CONTINENTAL MOTORS® AIRCRAFT ENGINE
SERVICE BULLETIN

CATEGORY 3
SB17-04

SUBJECT: Continental Motors Ignition Systems
Service Bulletin SB670

SERVICE BULLETIN**SB670**

Figure 1. Distributor Block Batch-Codes, (S-20, S-200, typical)

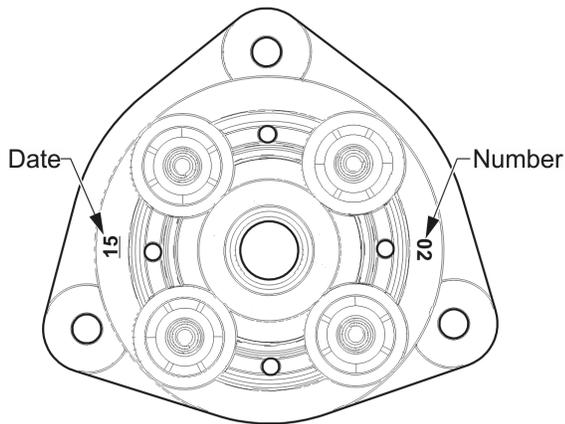
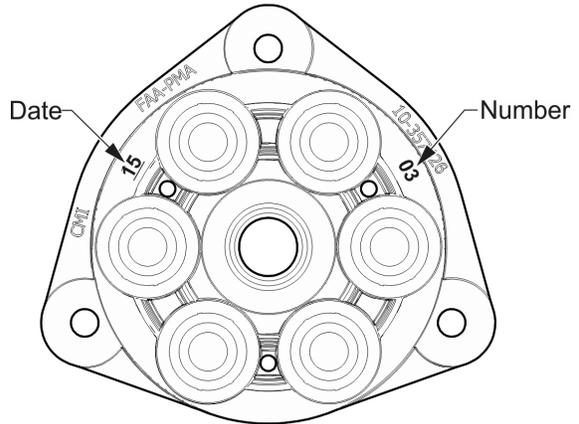
1. Locate the distributor block batch-code as shown in Figure 1 and Figure 2.
2. Replace distributor blocks bearing superseded batch-codes with acceptable batch codes as shown in Table 1. Destroy distributor blocks with superseded batch-codes after removal.

Batch-Code = Date (YR), Dash, Number
 i.e. Batch-Code = 15-02 (Acceptable)

Batch-Code = Date (YR), Dash, Number
 i.e. Batch-Code = 15-03 (Acceptable)
